THM 4L60-E 13 VANE PUMP, ROTOR AND SLIDE FOR 1997

CHANGE: Beginning at the start of production for all 1997 models, there was a new design 13 vane pump

Figure 1
AUTOMATIC TRANSMISSION SERVICE GROUP

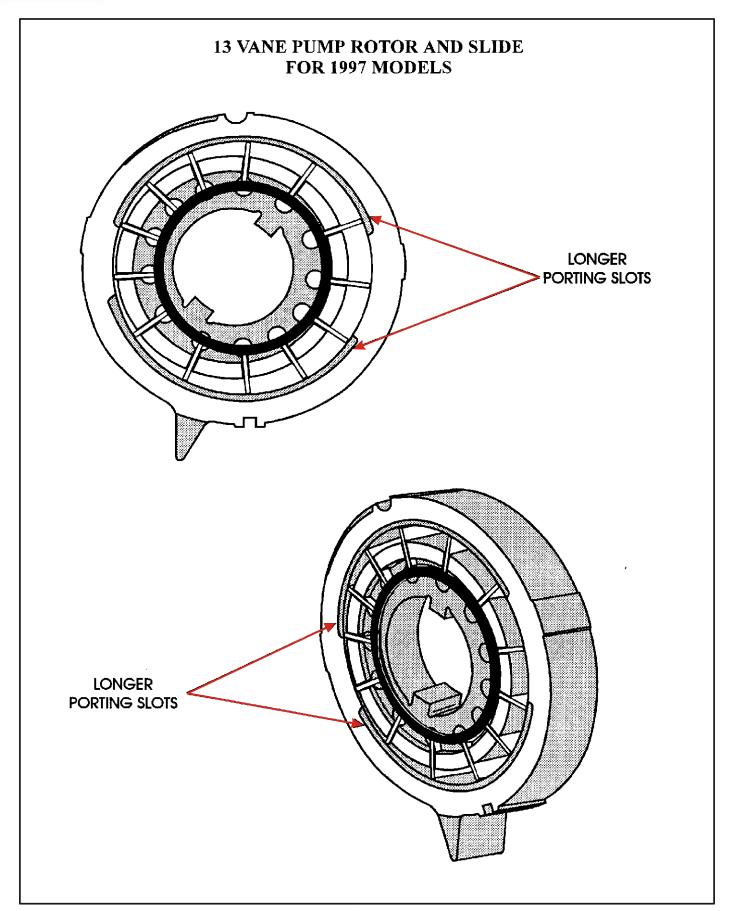
rotor and new design pump slide installed in all THM 4L60-E transmissions (See Figure 1).

- (1) OIL PUMP ROTOR Now has 13 vanes in the pump rotor instead of the previous 10 vanes, as shown in Figure 1.
- (2) OIL PUMP SLIDE Now has longer porting slots on the face of the slide (See Figure 1).
- (3) ROTOR GUIDE Now has 13 slots in the rotor guide to accommodate the added vanes.
- (4) OIL PUMP COVER Now has different configuration on the porting slots in the pump cover. The 13 vane pump cover can to accommodate the changes in the pump slide (See Figure 2). be easily identified with "13 V" cast into the back side in the location shown in Figure 3.
- (5) VANE RINGS Material change to increase vane ring durability.

Figure 2

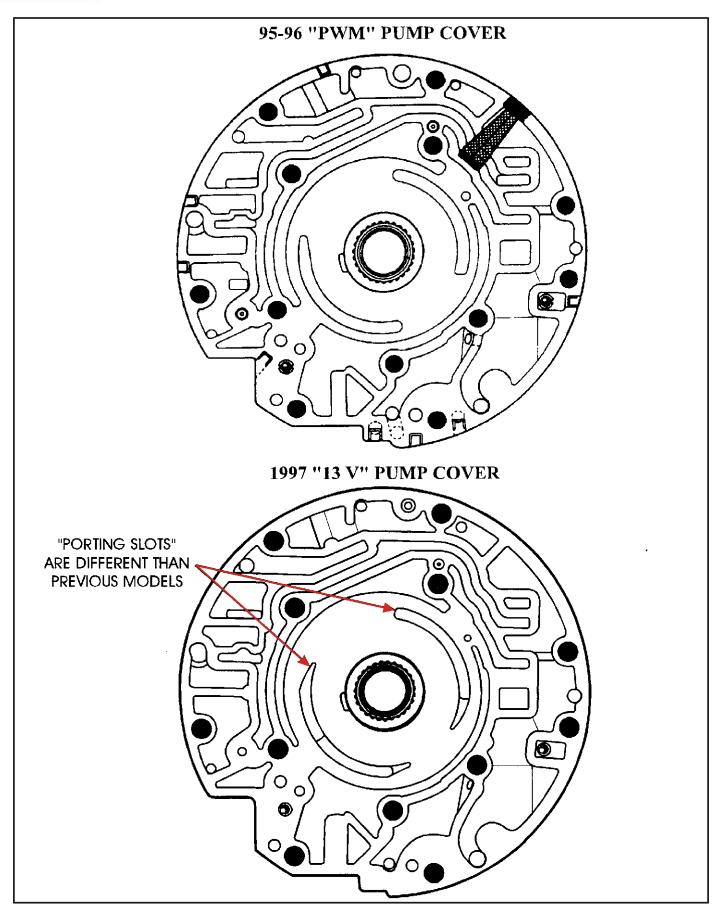
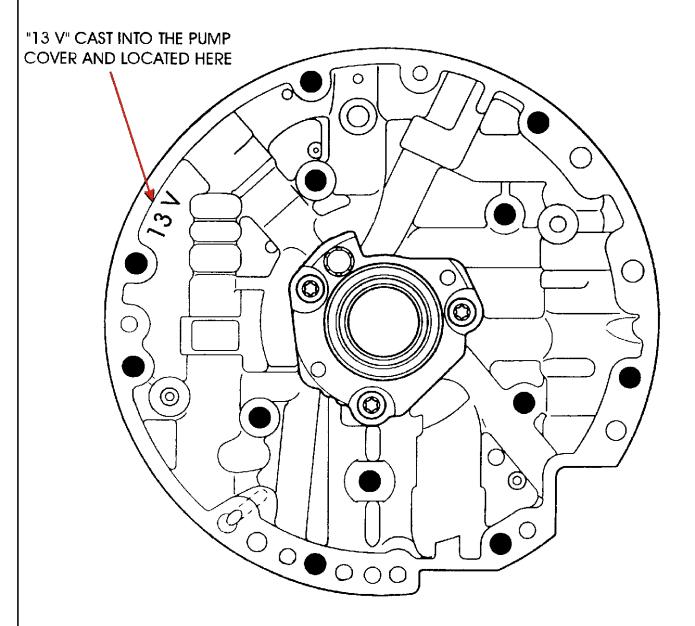
1997 13-VANE PUMP COVER IDENTIFICATION

THIS PUMP COVER WILL NOT INTERCHANGE WITH PREVIOUS MODELS.
IT MUST BE USED WITH THE 13 VANE ROTOR AND SLIDE.
